AGENDA ITEM 7
PLANNING & DEVELOPMENT SERVICE
PLANNING DIVISION
455 Mountain Village Blvd.
Mountain Village, CO 81435
(970) 728-1392

RE: Staff Memo – Final Architecture Review (FAR) Lot 649R-11, 11 Boulders Way

APPLICATION OVERVIEW: New Single-Family Home on Lot 649R-11

Agenda Item #8
PLANNING AND DEVELOPMENT SERVICES
DEPARTMENT

Utility Plan

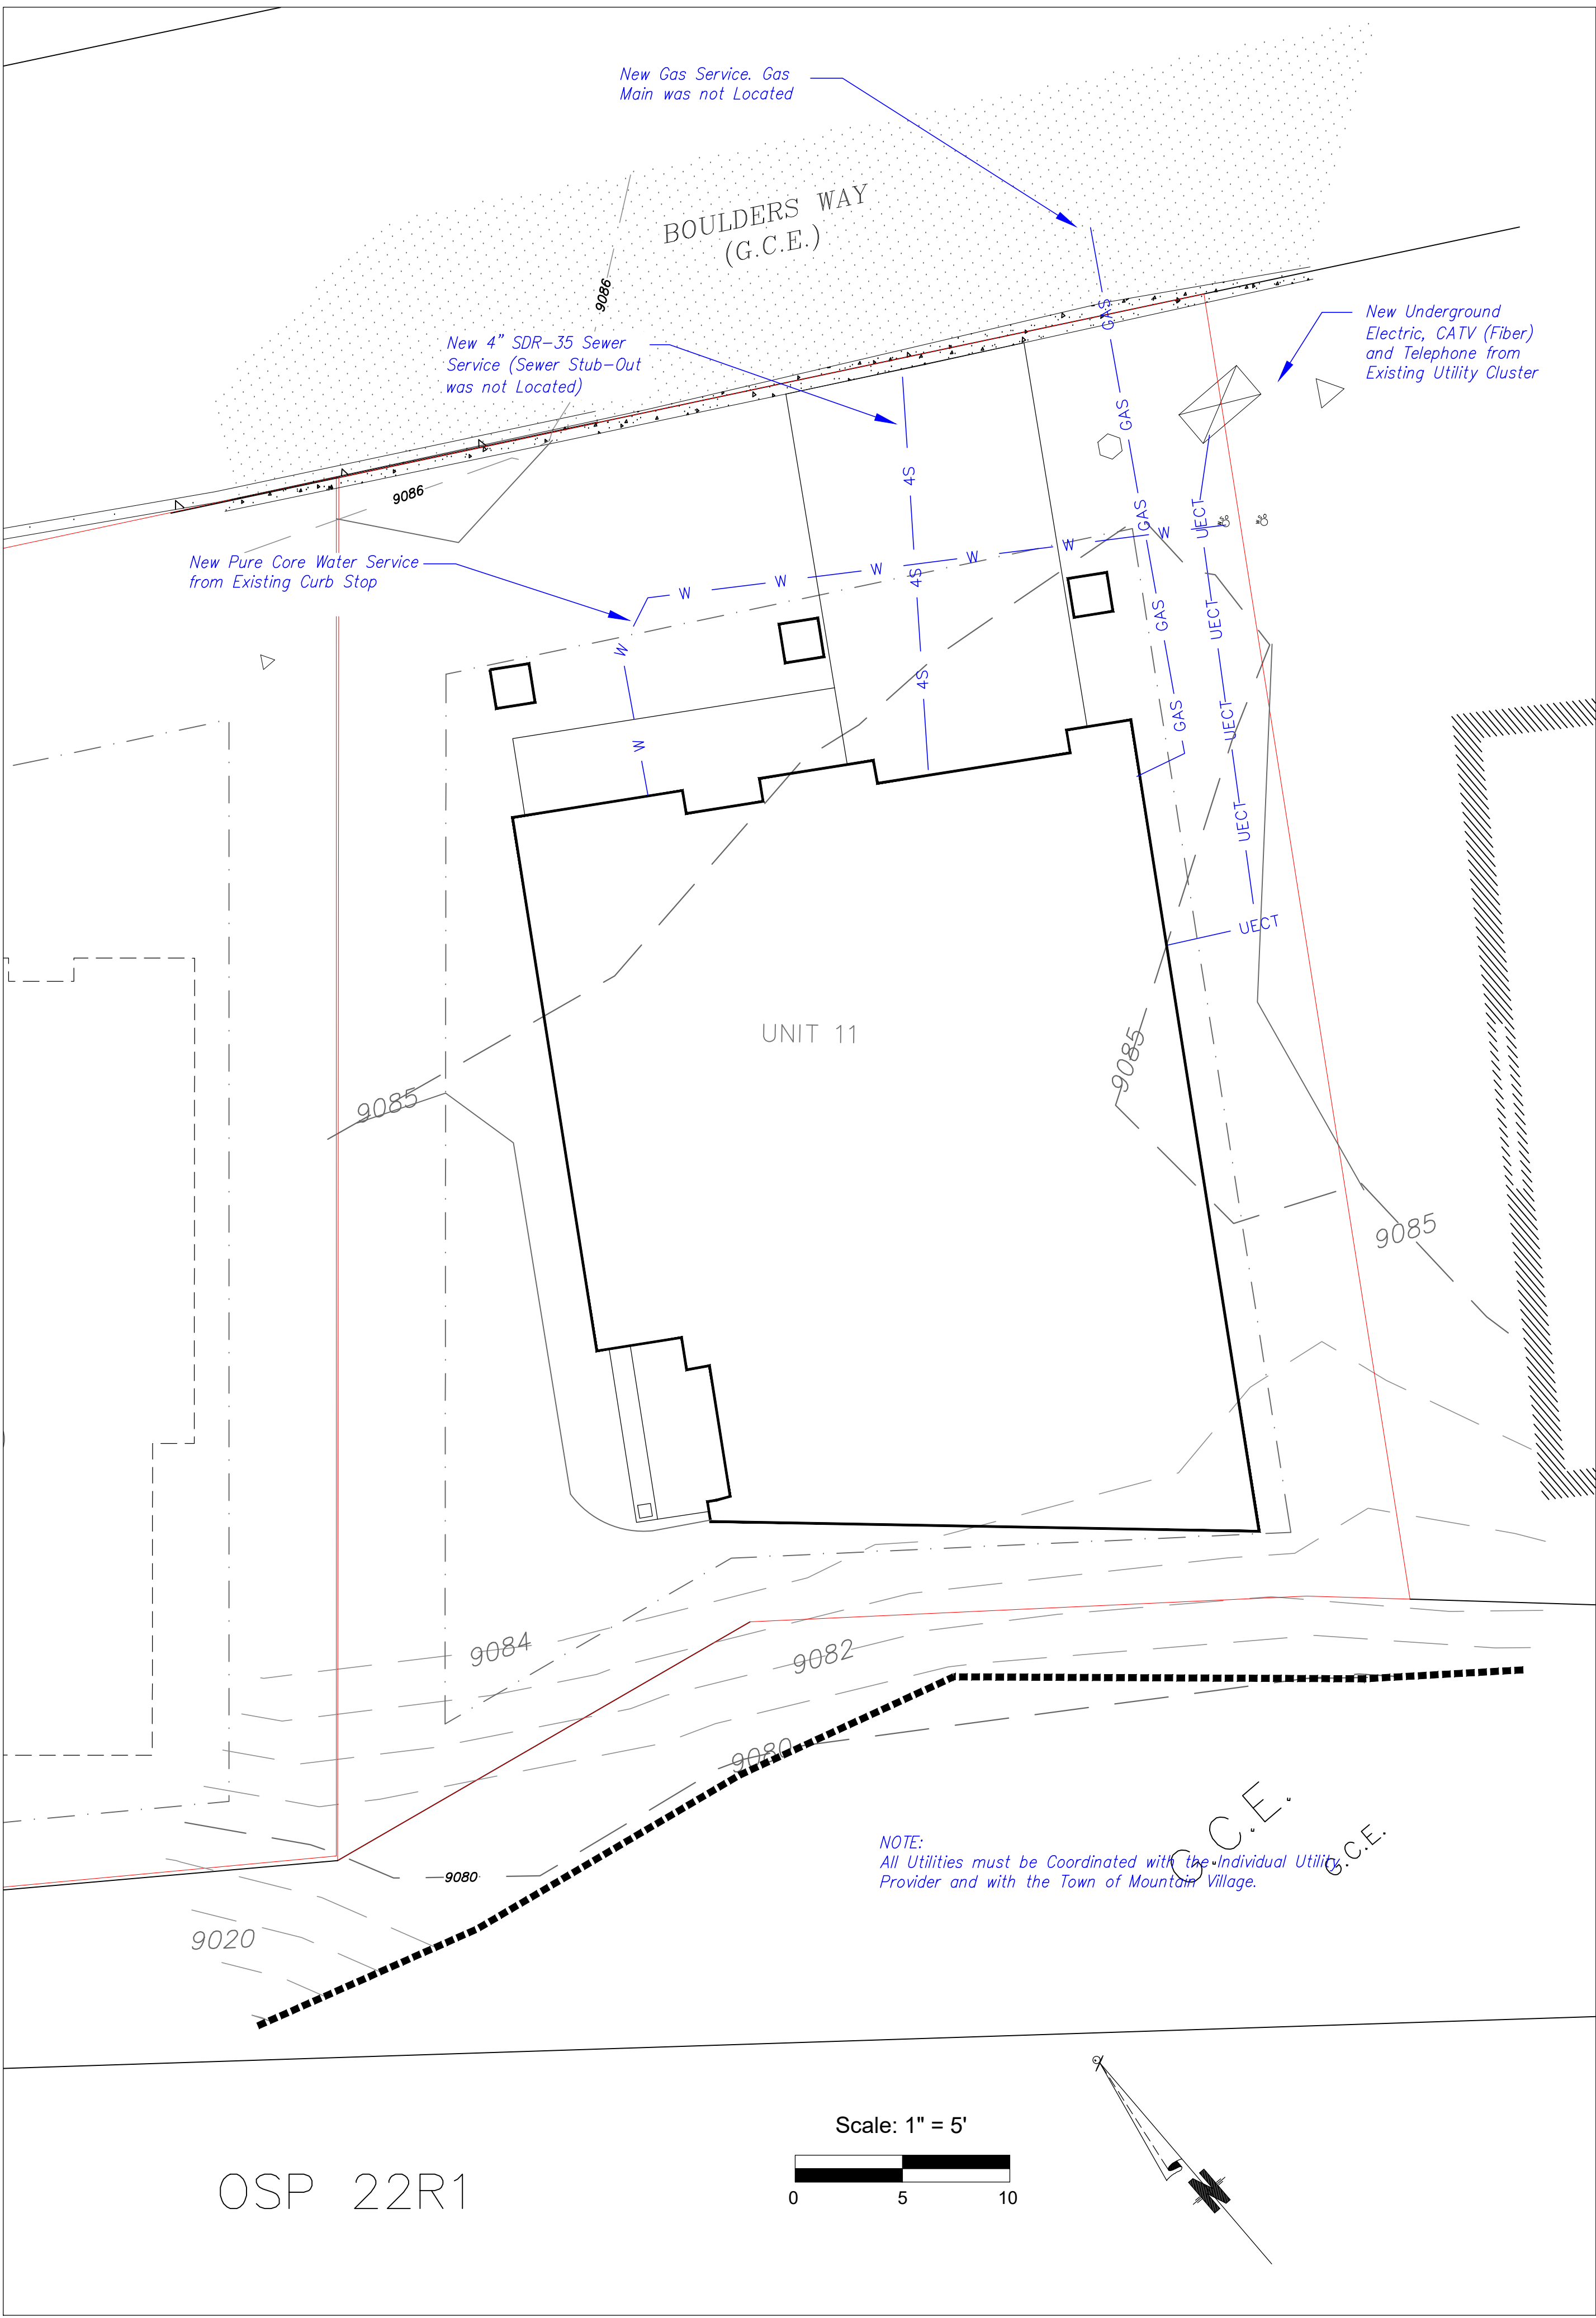
Staff: The applicant has revised the utility plan so that the utilities no longer impact Unit 12. Staff takes no additional issue with this revised plan. Staff recommends as a condition of approval, that the meter locations be specified on their building permit submittal as to verify that any necessary screening precautions are captured.

ARCHITECTURAL
SITE PLAN

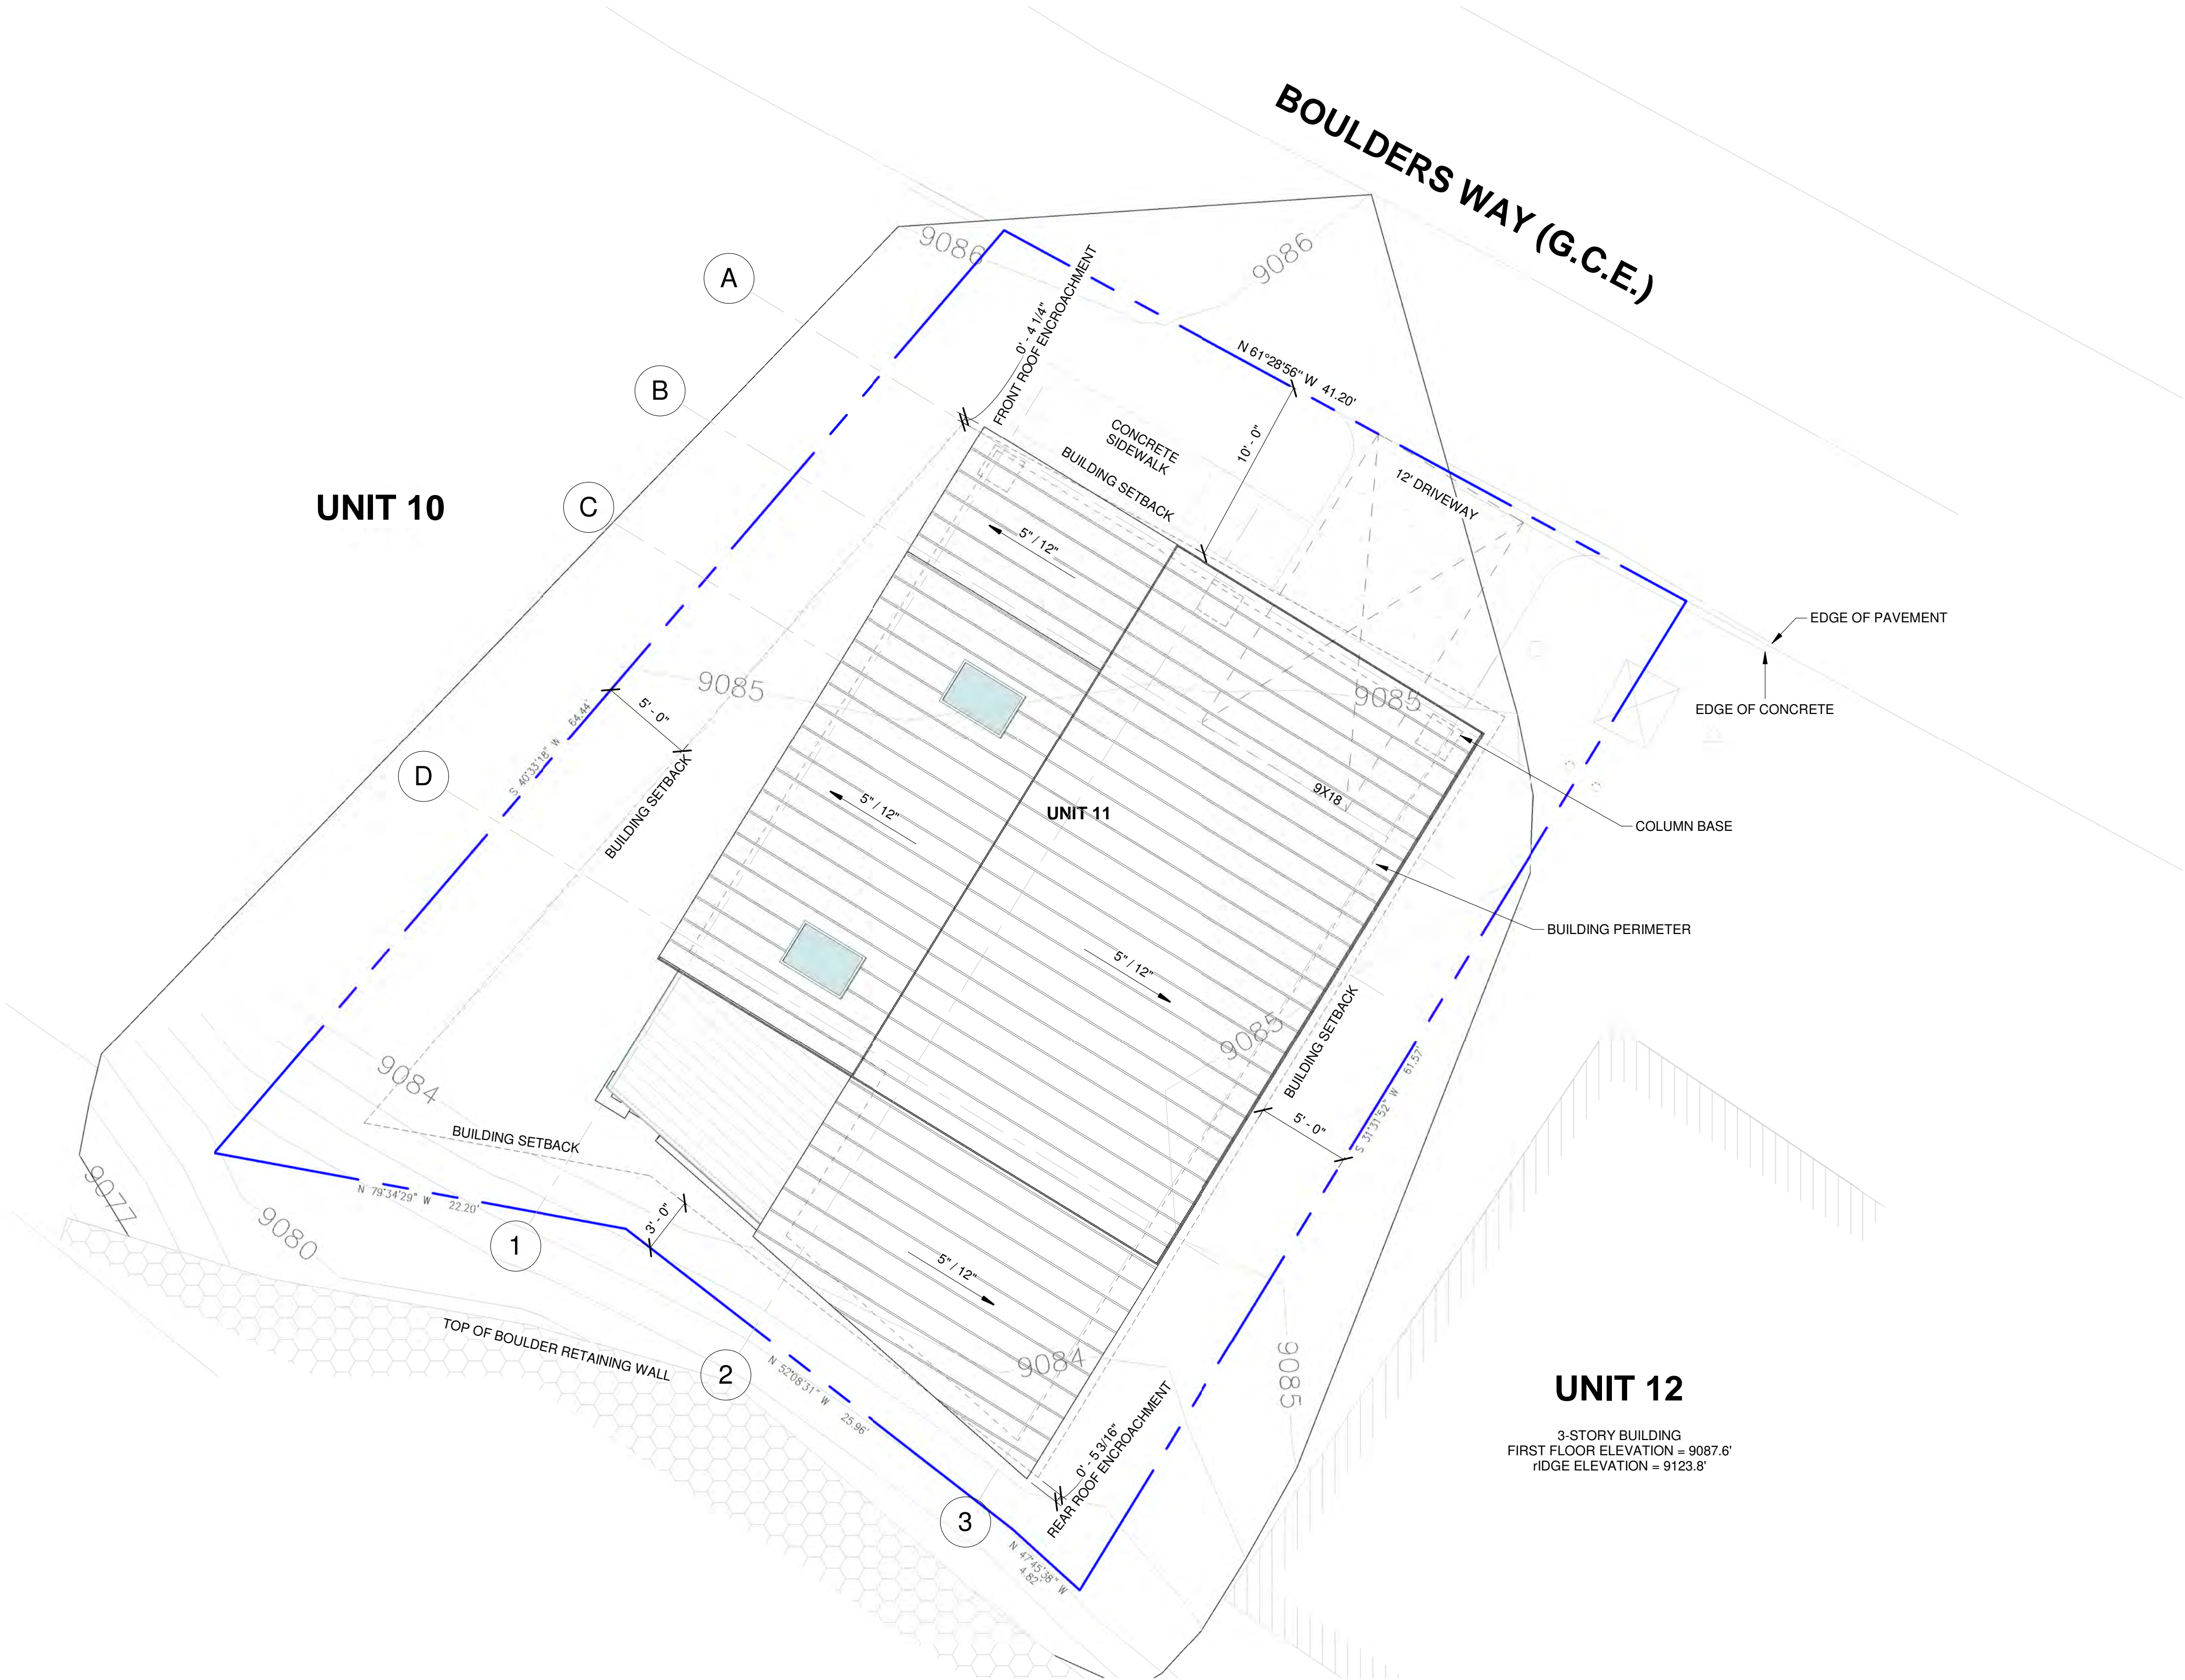
Staff: The applicant has shown one interior parking space and one exterior space on their architectural site plan. The CDC requires two spaces in multi-family development outside of the Village Center and does not designate interior vs. exterior parking. The parking configuration as shown will require DRB specific approval of tandem parking, but this is not atypical in the Boulders subdivision. Due to the limited size of the Lot, the applicant has proposed a portion of the exterior space be located within the front setback

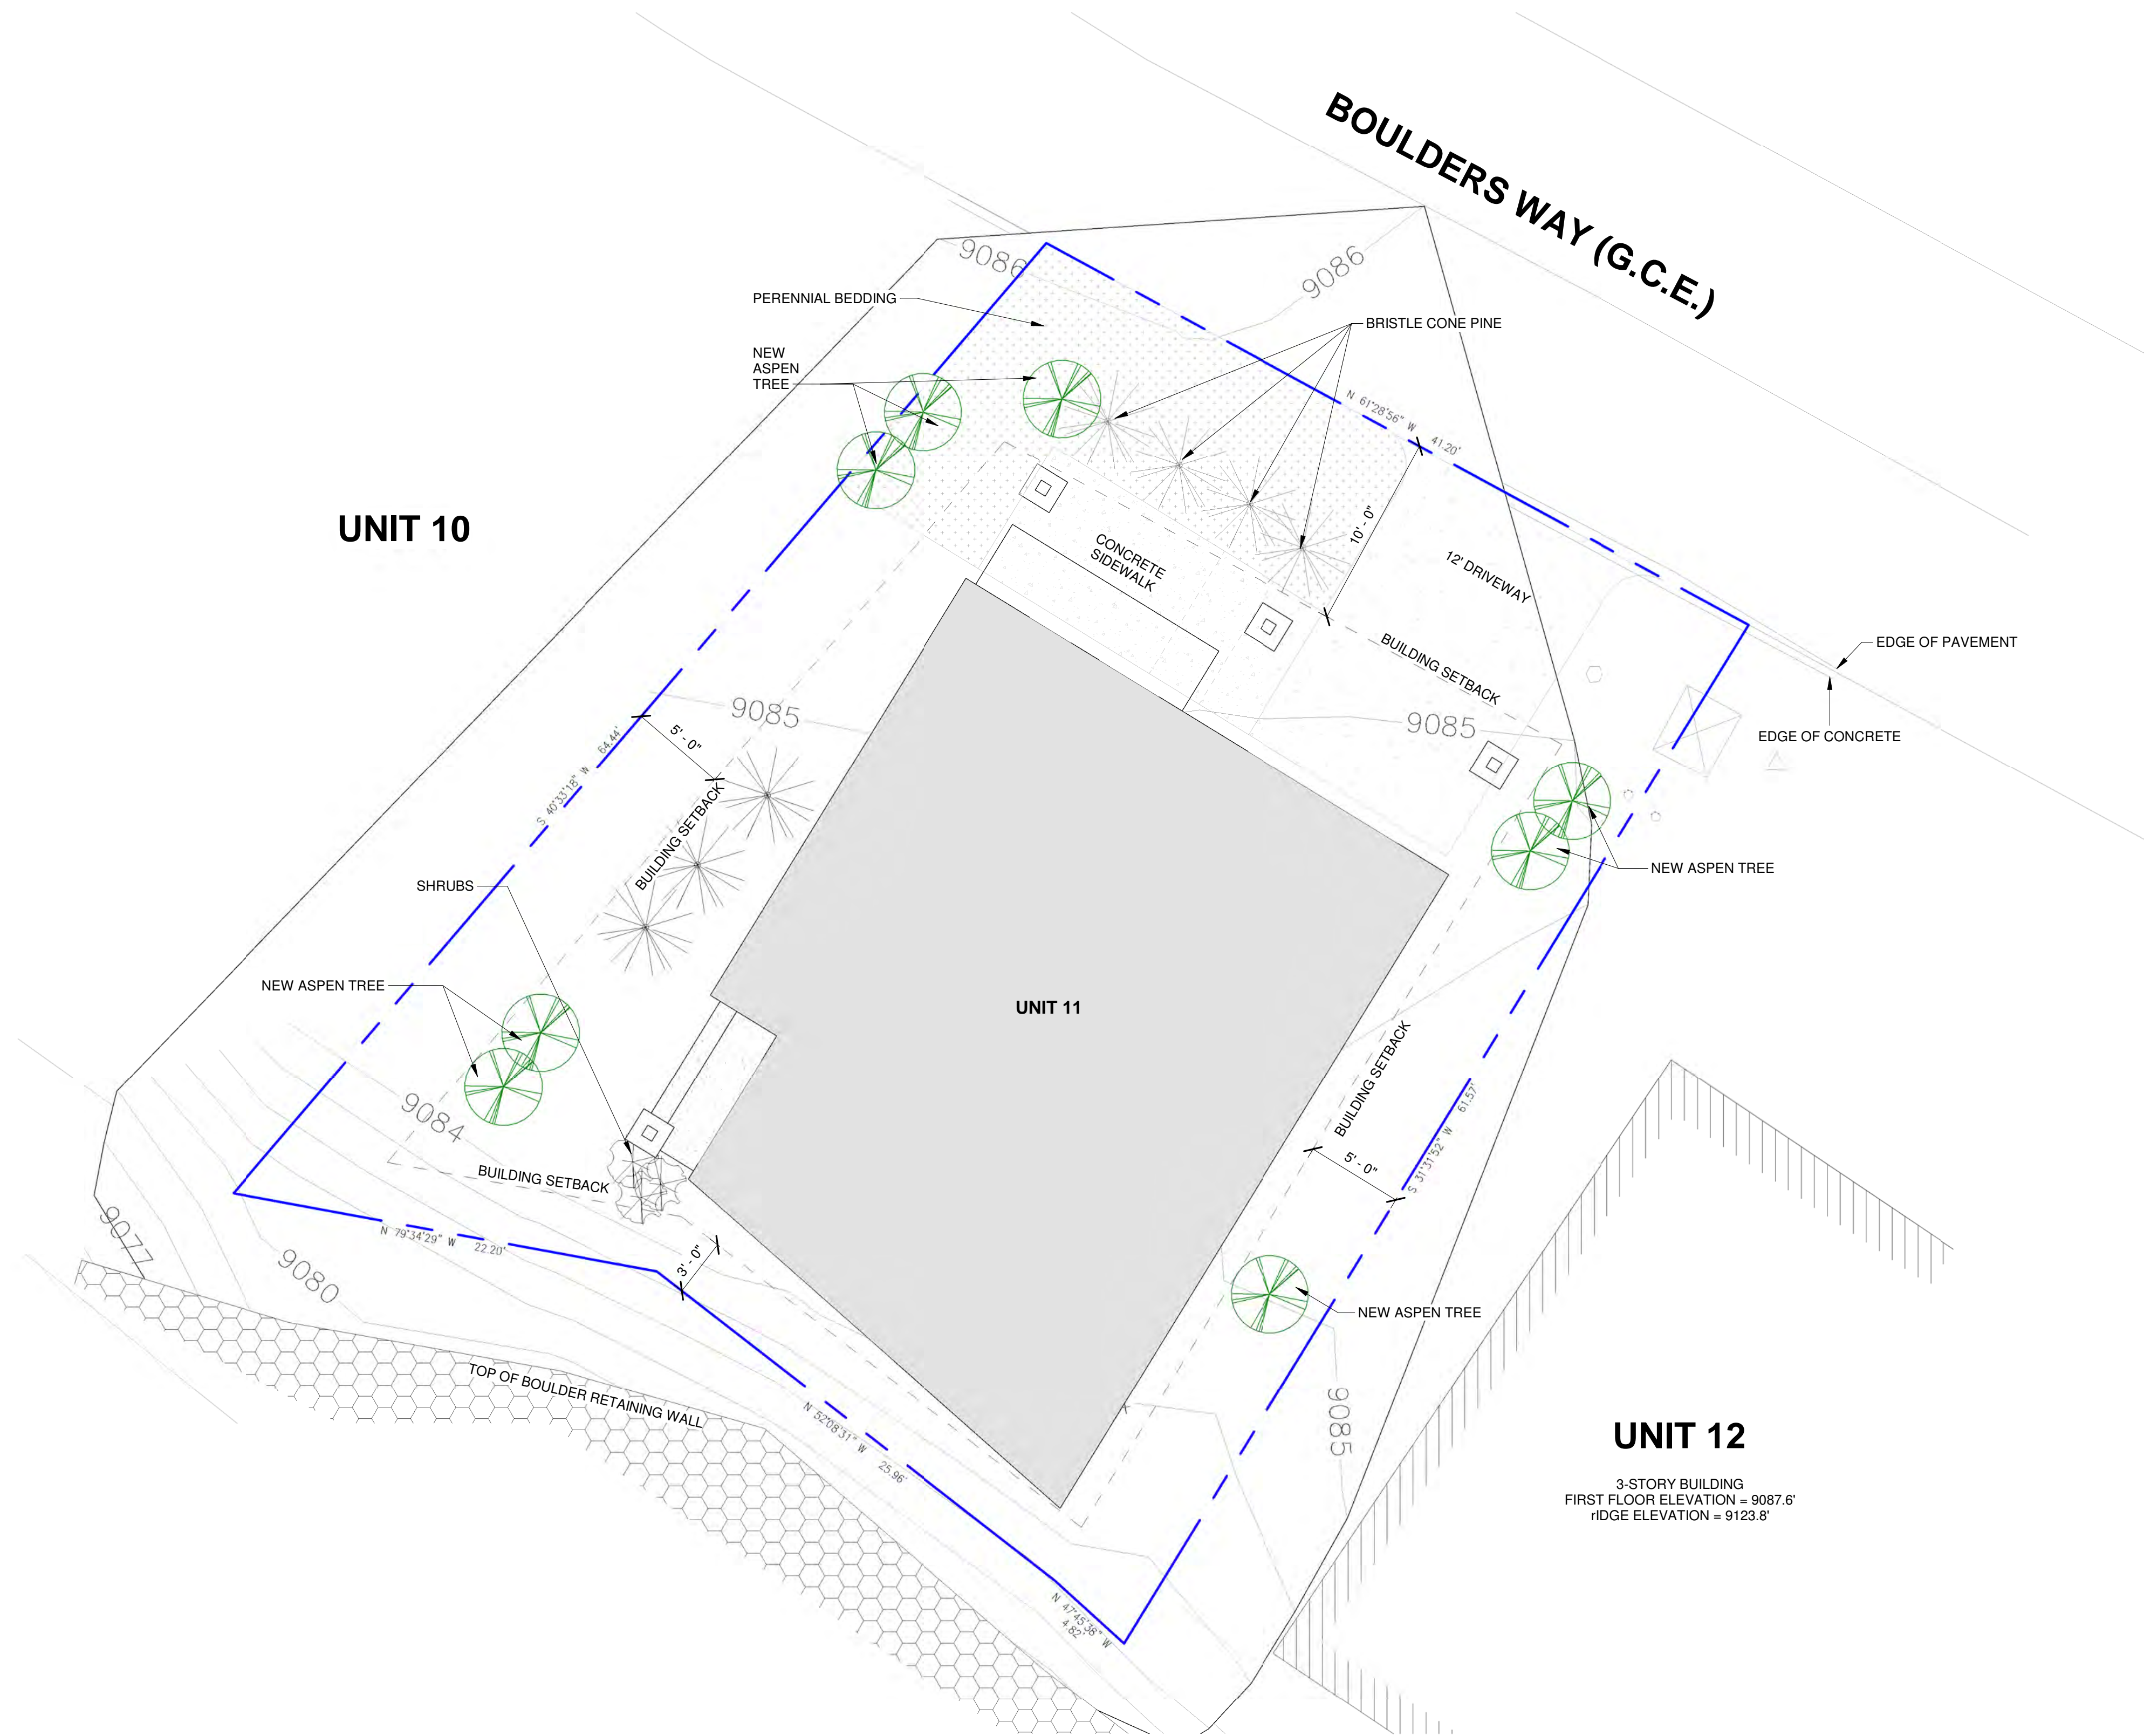
Staff: The applicant has revised their landscaping plan to now comply with the Landscaping regulations and is no longer requesting a design variation for this item.

Diversity of plantings clause was not met. Only aspen plantings are planned.
